STORM LINE B

JUNCTION BOX MODIFICATIONS

REFER TO REVISED SHEETS C6.1 AND C10.0 WITH HAND SKETCHES.

STR 7-B

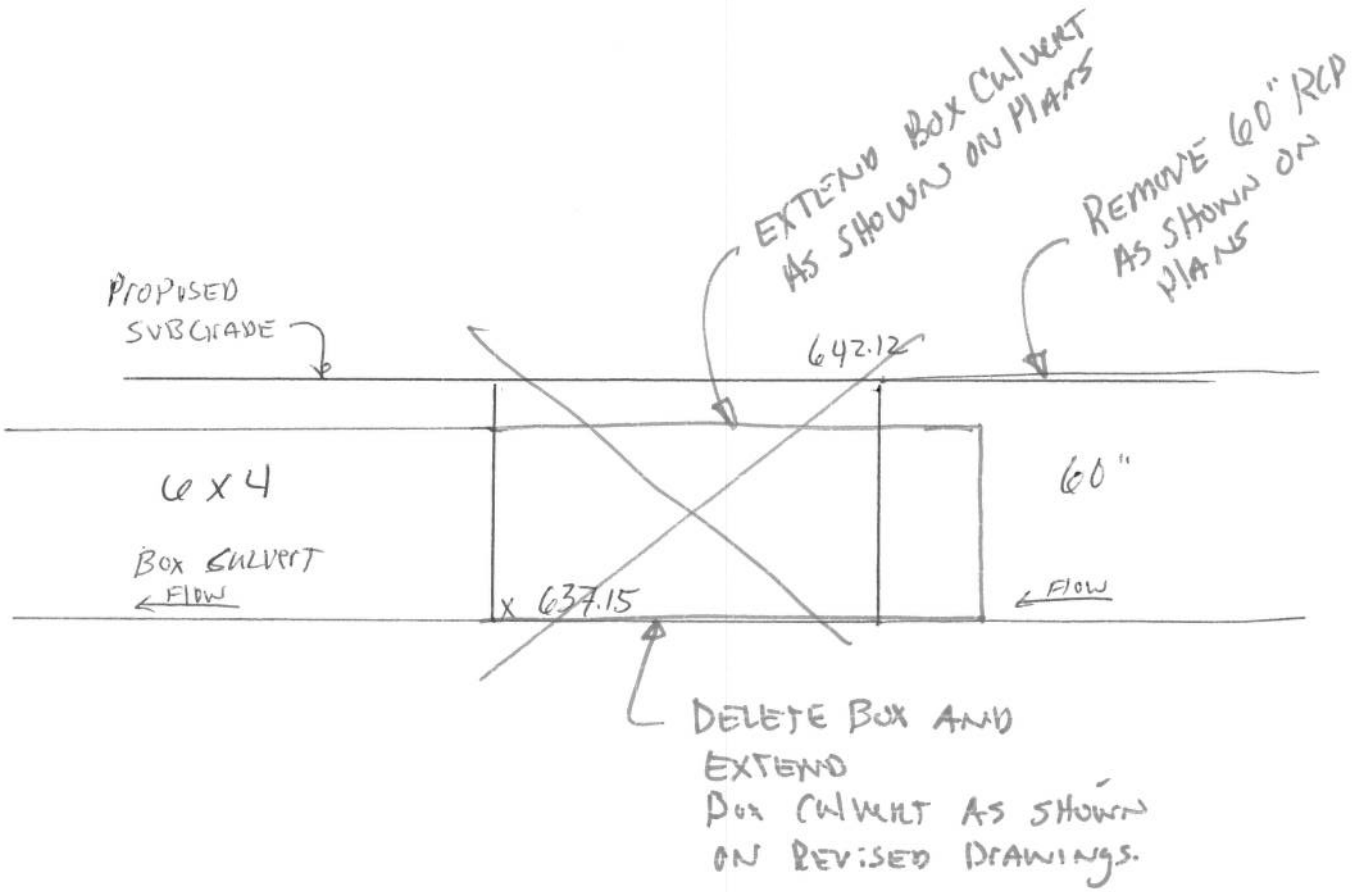
* BOTTOM OF BOX is only thing installed
- FRAMING + Rebar FOR sidewalls & TOP will have to be REMOVED

STR 8-B

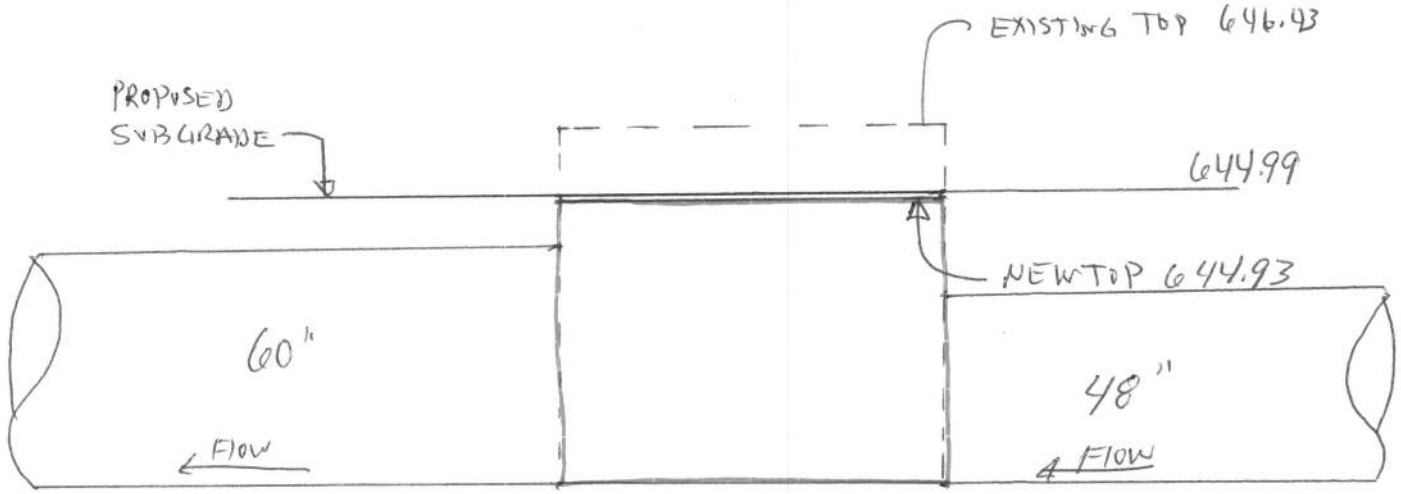
* REMOVE 1.5' of BOX

CONTRACTOR TO ADJUST RISERS TO MATCH REVISED THROAT ELEVATIONS.
SEE SHEET C10.0 of REVISION 15.

STR 9-B

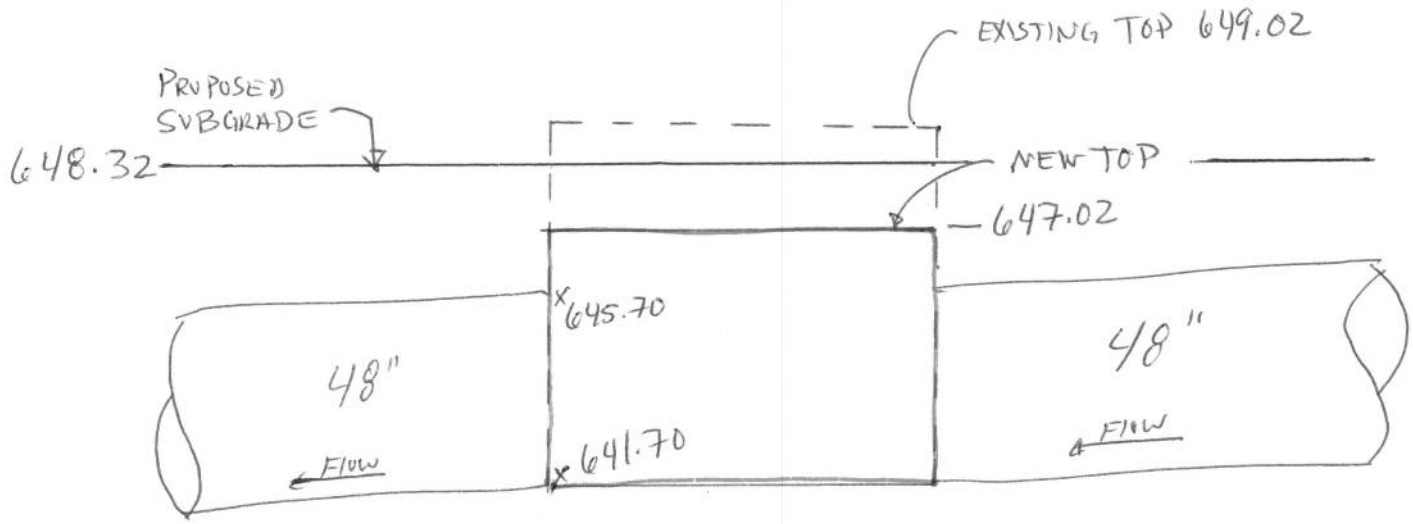
* CUT 2' OFF EXISTING BOX

CONTRACTOR TO ADJUST RISERS TO MATCH REVISED THROAT ELEVATIONS.
SEE SHEET C10.0 OF REVISION 15.

STR 10-B

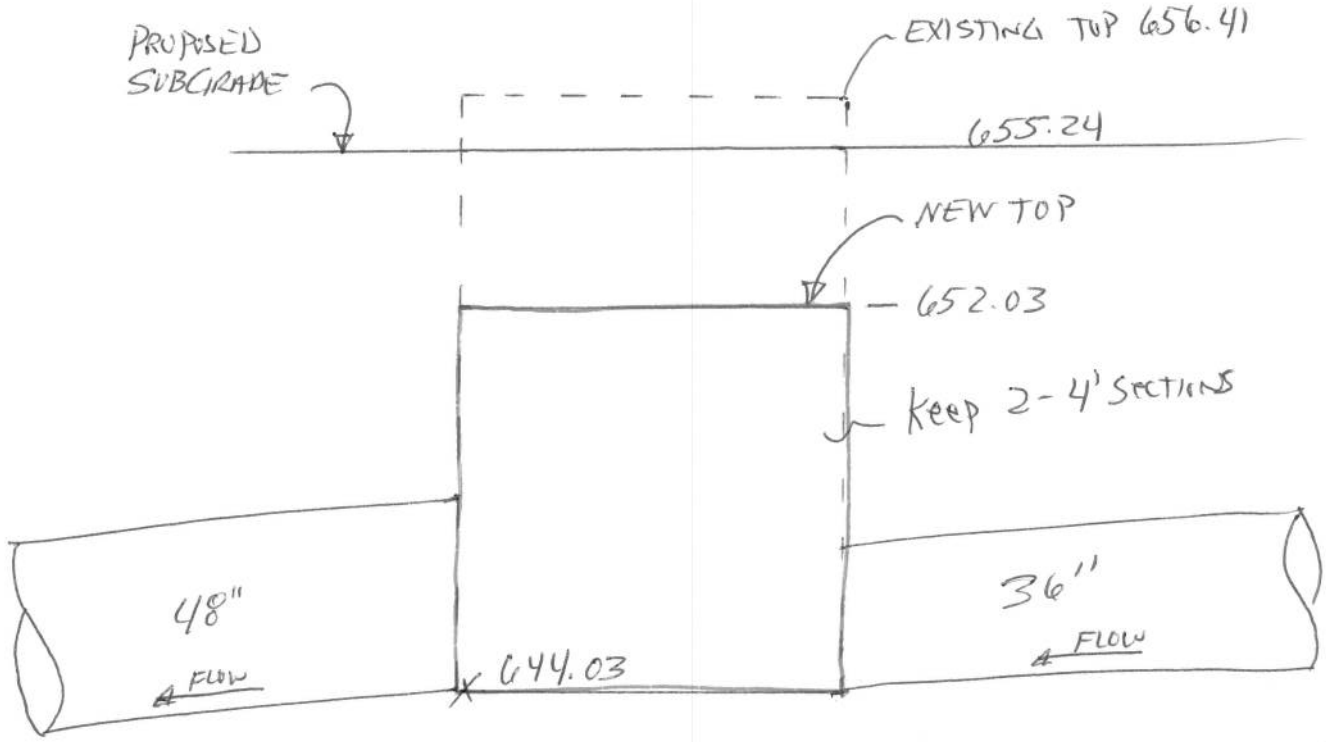
* REMOVE 1-4' SECTION

CONTRACTOR TO ADJUST RISERS TO MATCH REVISED THROAT ELEVATIONS.
SEE SHEET C10.0 OF REVISION 15.
